ADDENDUM # 5 Bid 20C6, Waverly Elementary School - New Construction

ADDENDUM NO. 5

RE: **WAVERLEY ELEMENTARY SCHOOL REPLACEMENT**

This addendum forms a part of the Contract Documents and modifies the original Bidding Documents dated March 16, 2020. Acknowledge receipt of this Addendum in the space provided on the Form of Proposal.

1 SECTION DETAIL
 ADD5.8 1 1/2" = 1'-0"
 DETAIL 12/A6.11

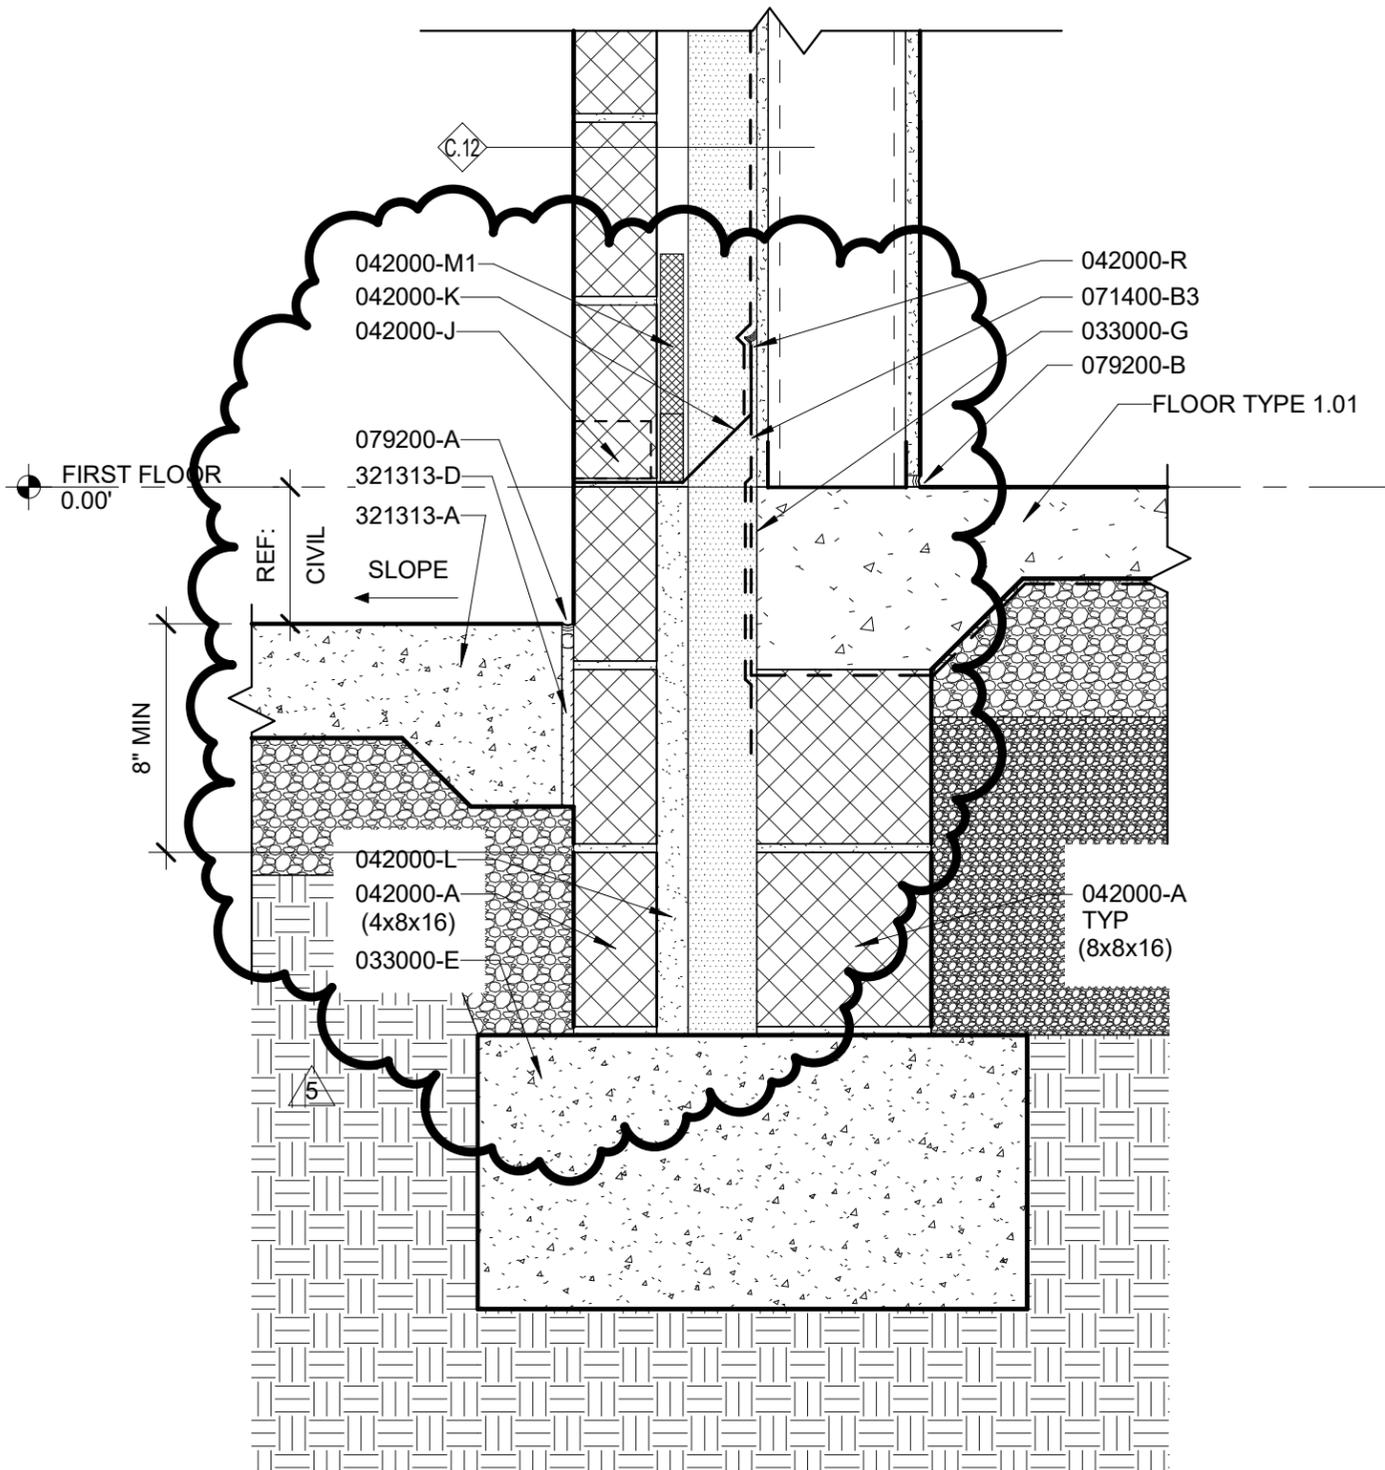
- **REVISE** detail 12 as indicated in Sketch ADD5.8 issued as part of this addendum.
15. **REVISE** Drawing Sheet A6.12 – SECTION DETAILS; Issued for Bid, dated 03/06/2020.

1 SECTION DETAIL
 ADD5.9 1 1/2" = 1'-0"
 DETAIL 9/A6.11

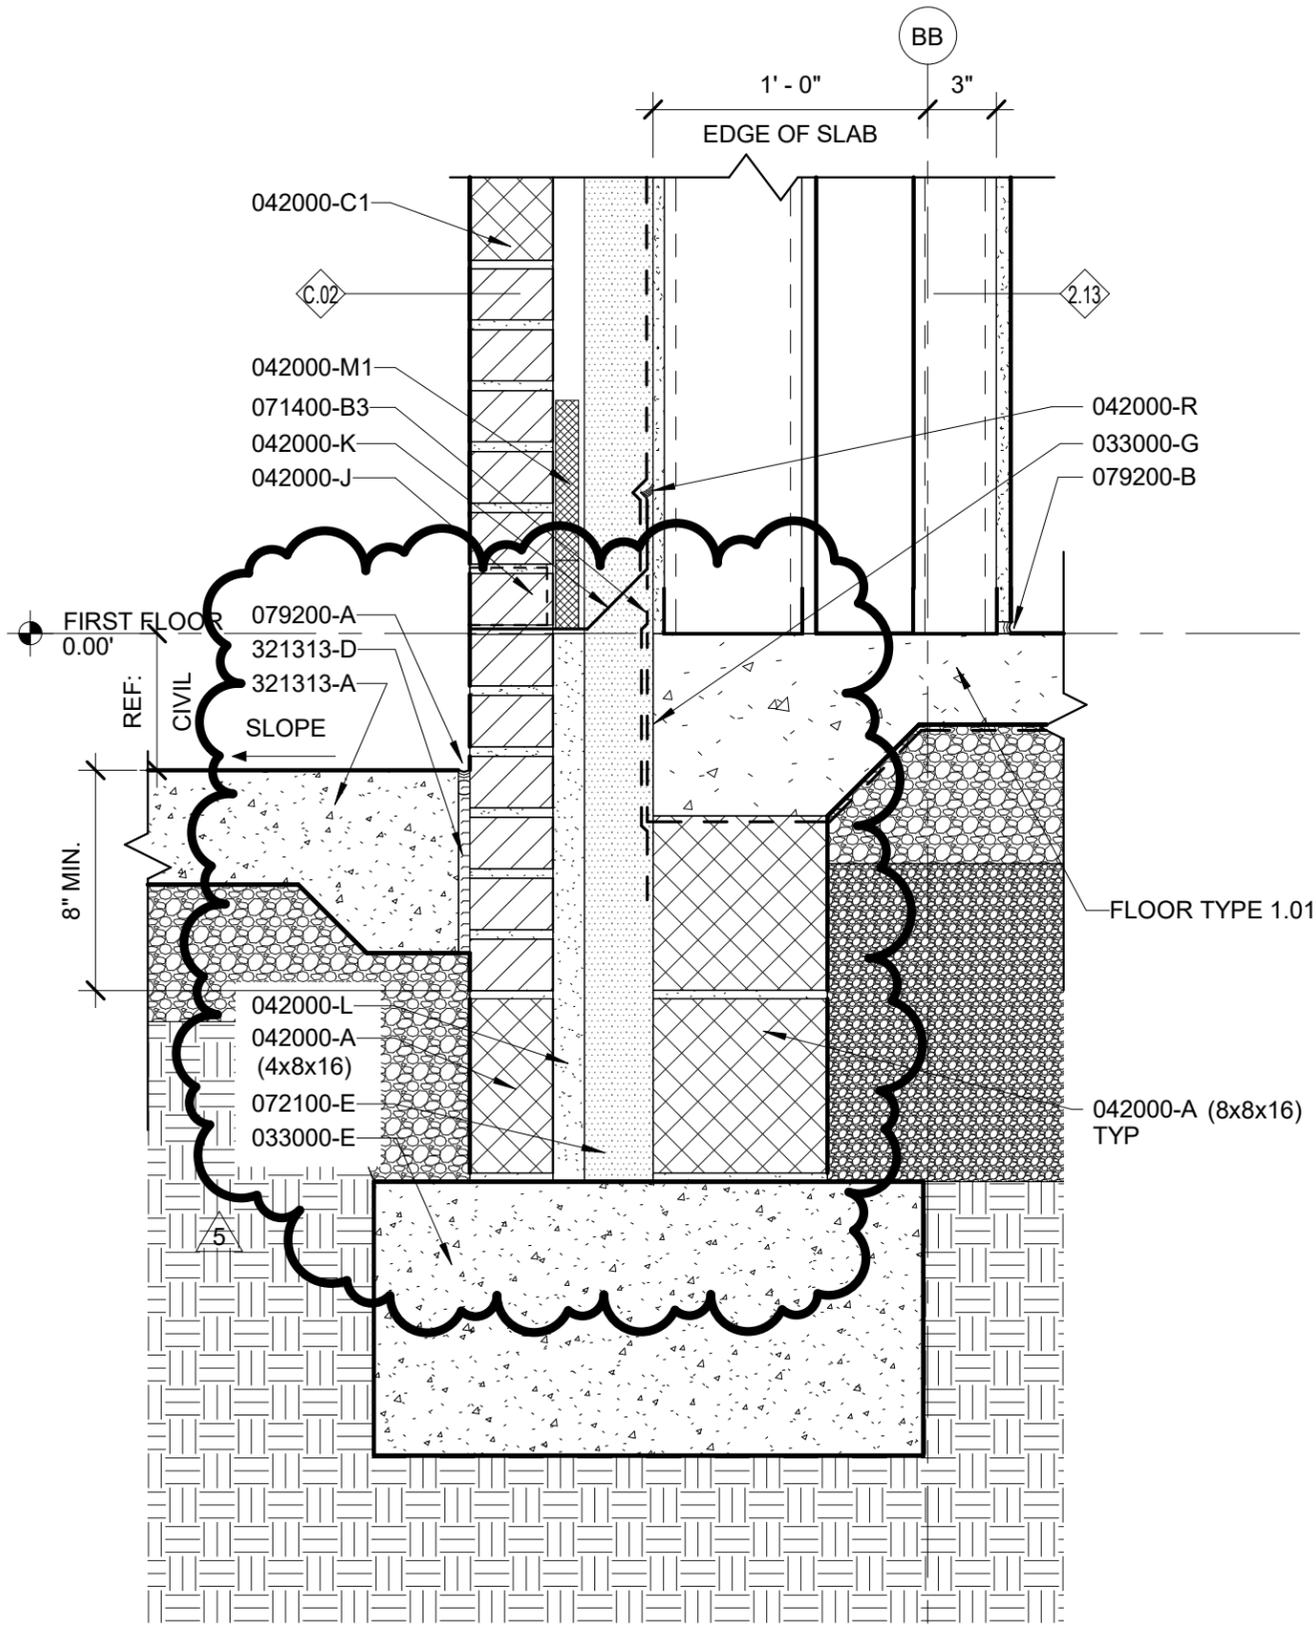
- **REVISE** detail 9 as indicated in Sketch ADD5.9 issued as part of this addendum.
 - **REVISE** detail 10 as indicated in Sketch ADD5.7 issued as part of this addendum.

SKETCH NO. ADD5.11

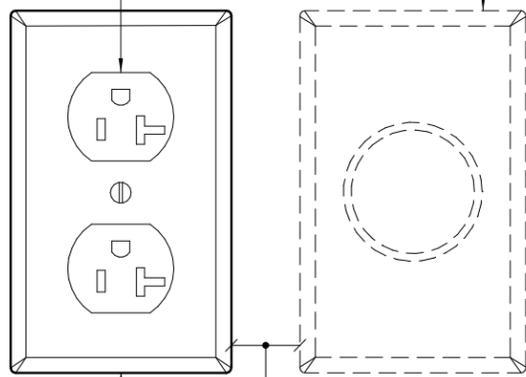
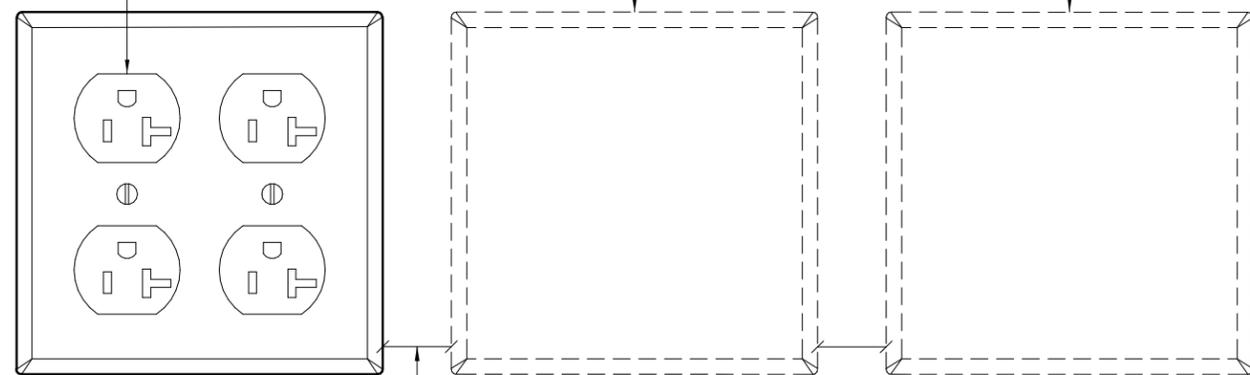
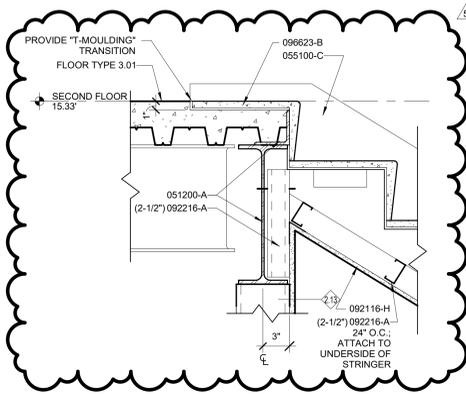
15. Drawing E0.1 and power drawings indicate there are teacher drops and smartboard drops but there are no details provided for the drops on drawing E6.4.

- **REVISE** “Secondary Wiring” for transformer TKR to “(4) #4/0 + #2 SSBJ - 2 1/2”C”.
 - **REVISE** “Primary Wiring” for transformer TRRE to “(3) #1/0 + #6GW - 2”C”.
 - **REVISE** “Secondary Wiring” for transformer TRRE to “(4) #4/0 + #2 SSBJ - 2 1/2”C”.
4. **REVISE** Drawing Sheet E6.3 – ELECTRICAL DETAILS; Issued for Bid, dated 03/06/2020.
- **ADD** details for Teacher and Smartboard Drops on Sketch ADD 5.11 included with this addendum.

The drops indicated on the electrical drawings refer the contractor to the details for power and back box coordination. It was done to inform the contractor to provide both power and data at that location. Refer to the power plans for the power requirements and refer to the data plans for data and back box for telecom.

WAVERLEY ELEMENTARY SCHOOL REPLACEMENT			
MARYLAND PSC NO. 10.058.21 FREDERICK COUNTY PUBLIC SCHOOLS			
Job No.	#18045	EMG	Drawn
Scale	As indicated	JTH	Checked
Date	03/16/2020	PLH	Approved
Drawing Title	STAIR PLANS & SECTIONS		Drawing Number
			A5.2
Sheet			Of

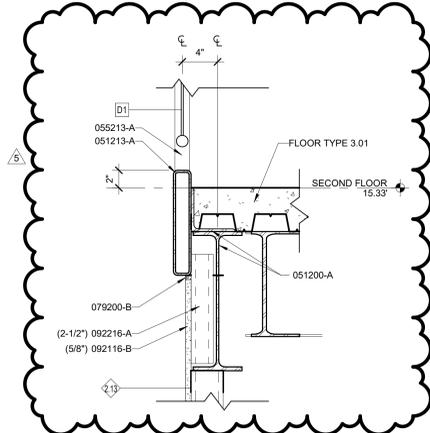
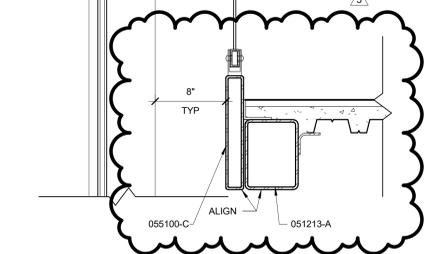
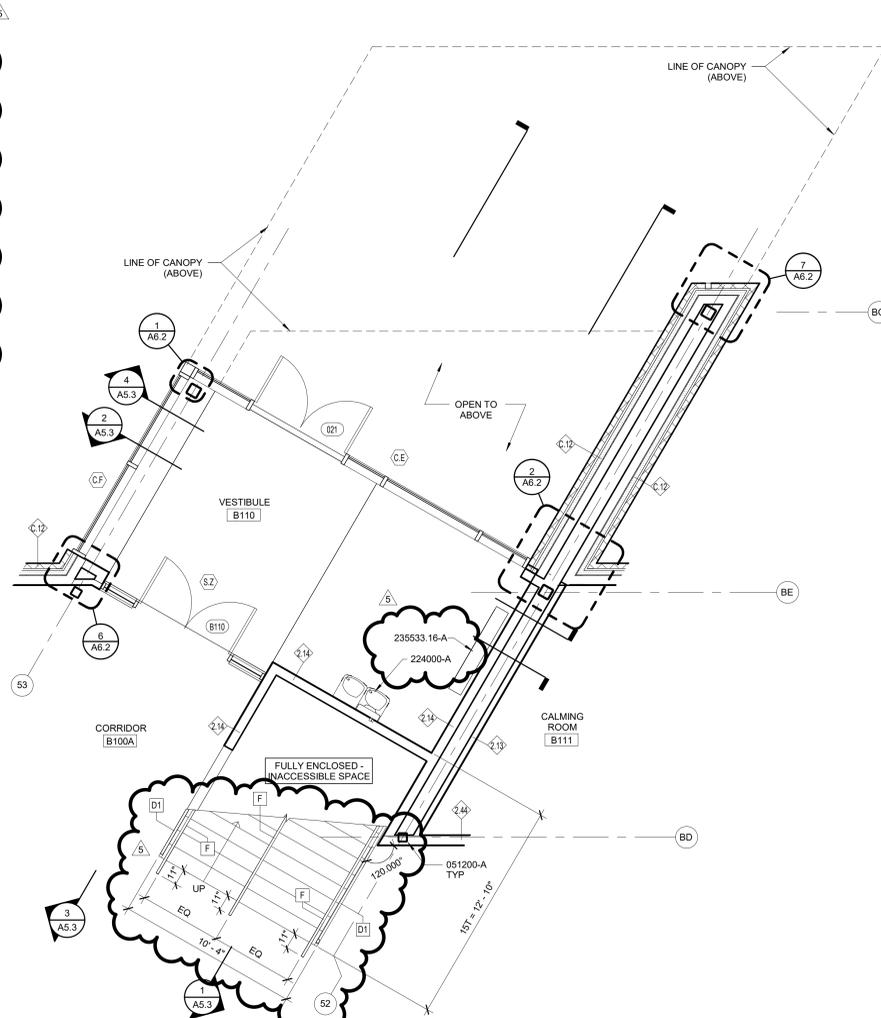
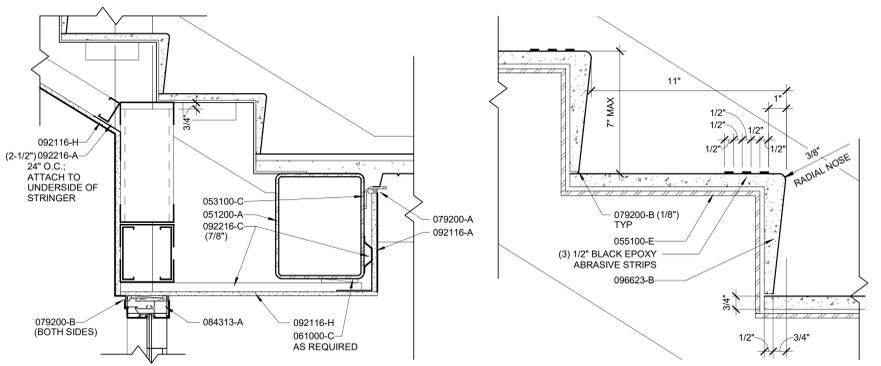
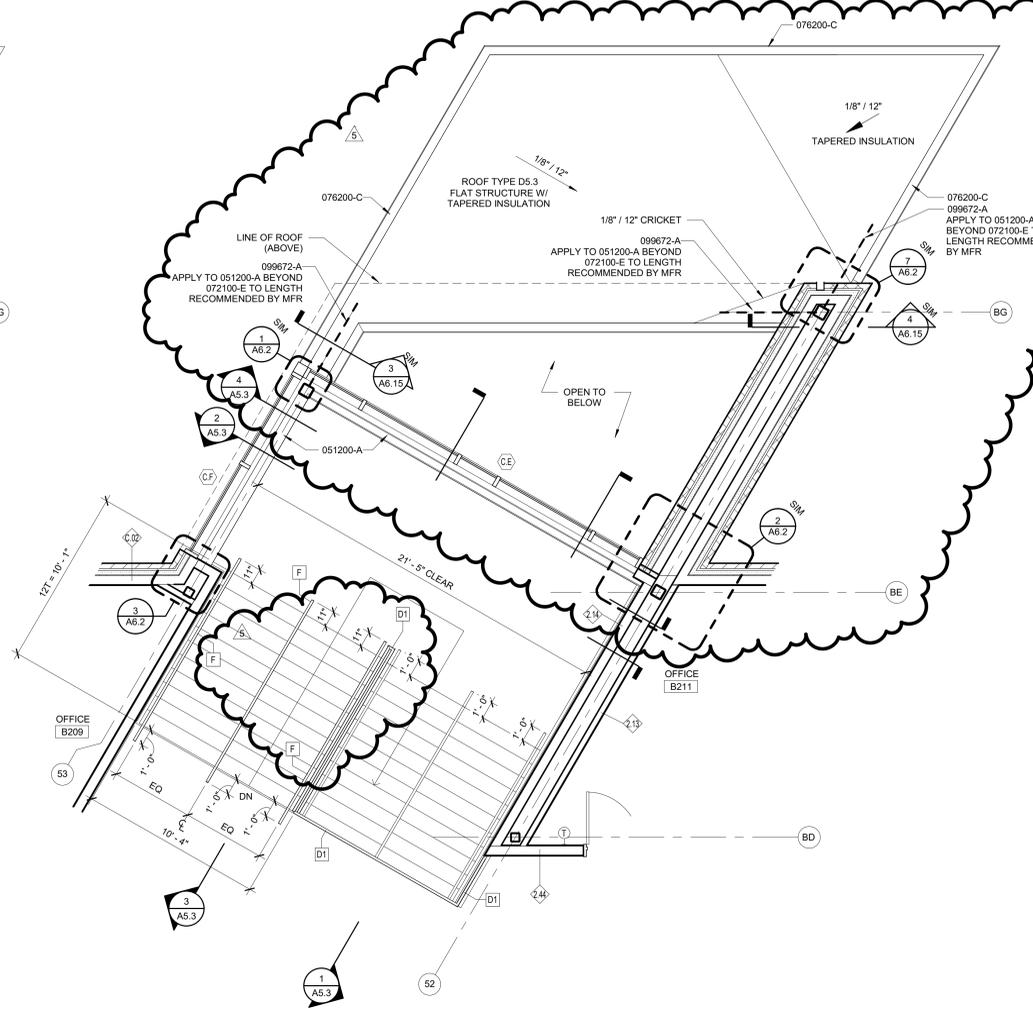
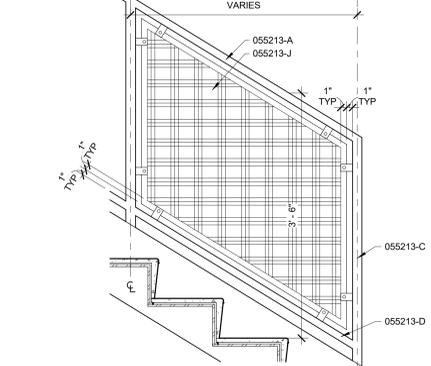
- **REVISE** all instances of “Ceiling Type 1.12” to be “Ceiling Type 1.11”.
10. **DELETE** Drawing Sheet A5.2 – STAIR PLANS & SECTIONS; Issued for Bid, dated 03/06/2020; **ADD** Drawing Sheet A5.2 – STAIR PLANS & SECTIONS; ADDENDUM #5 (Revision dated 04/15/2020).

- **REVISED** drawing 2/A5.2 (now 4/A5.2) to show roof plan information for canopy.
 - **REVISED** railing types in drawings 1/A5.2 (now 3/A5.2) and 2/A5.2 (now 4/A5.2).

9 3D DIAGRAM - AREA B - BUS ENTRY
A5.2 / 1/12" = 1'-0"

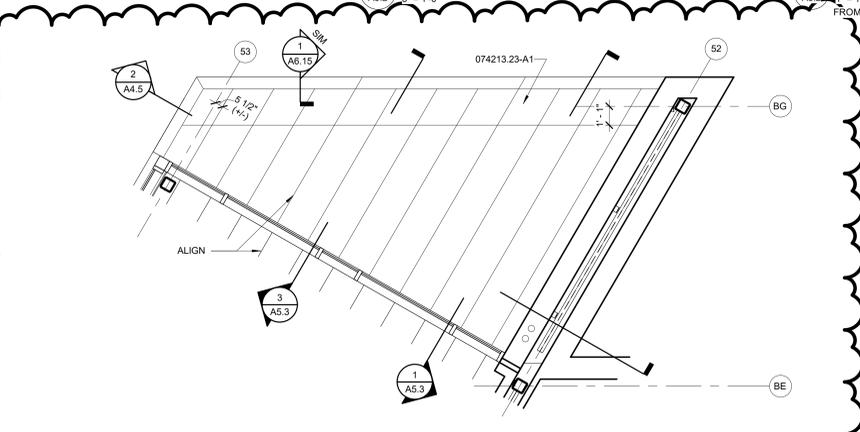
5. Can additional dwgs and details be provided for the expansion joint detail along column 51 at roof areas B and C?
6. Can additional 3D dwgs be provided for the canopies at roof area B? Similar to dwg page 150. Are the lower canopies free standing or attached to the building at B, C and E?

- **ADDED** 3D diagram of bus entry canopy (9/A5.2).
 - **ADDED** reflected ceiling plan of high overhang at bus entry (10/A5.2).
 - **ADDED** details 1, 2, 5, 6, 7 and 8/A5.2.

6. Yes, we have prepared additional roof plans, reflected ceiling plans and 3D views of the three lower canopies for release as part of a future addendum. The canopies are attached to the building and are not freestanding.
-
